REFERENCE: SNM-2500  
Docket 72-1  
TAC No. L23091

SUBJECT: Response to USNRC Request for Additional Information dated May 16, 2003

**Response to NRC Request for Additional Information dated May 16, 2003**

**General Electric Corporation  
Morris Operation  
Docket No. 72-1  
SNM-2500**

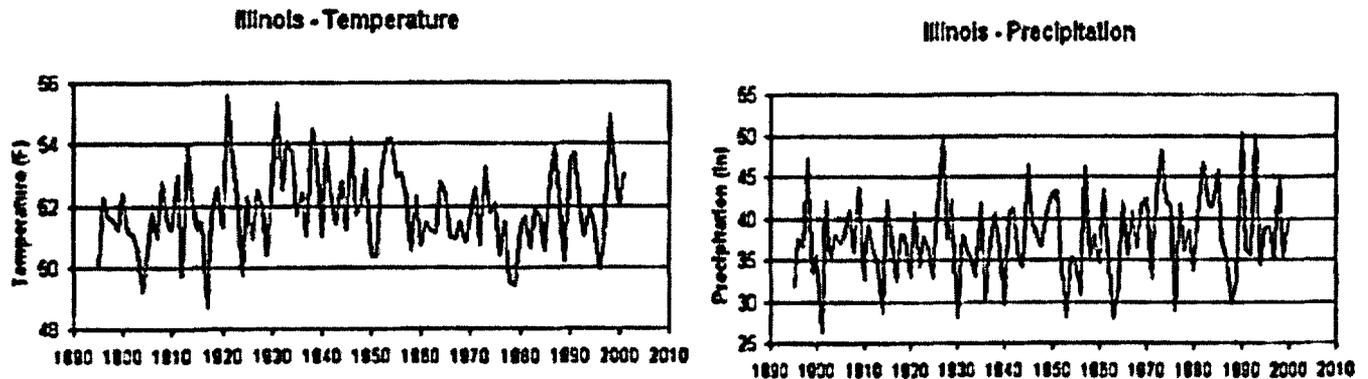
- a. Table 3-4 Aircraft flight information is from 1979;
- b. Table 3-6 Precipitation information is from 1964;
- c. Figure 3-8 Wind rose data is from 1971;
- d. Figures 3-3, 3-4, 3-5, and 3-6 Population Data is from 1990;
- e. Table 3-7 Thunderstorm activity information is from 1976;
- f. Table 3-8 Stability class and wind direction information is from 1974;
- g. Table 3-12 Water analysis information is from 1977; and
- h. Figure 7-1 History of Basin Water Activity ends in 1994.

**Response – a. The aircraft flight data in Table 3-4 is referenced to VOR flight tracking. As per FAA regional office, since flights use GPS now, this system is no longer used and an update of the info is not possible. The information was retained in the CSAR to depict there are no scheduled flight lanes over GE-MO.**
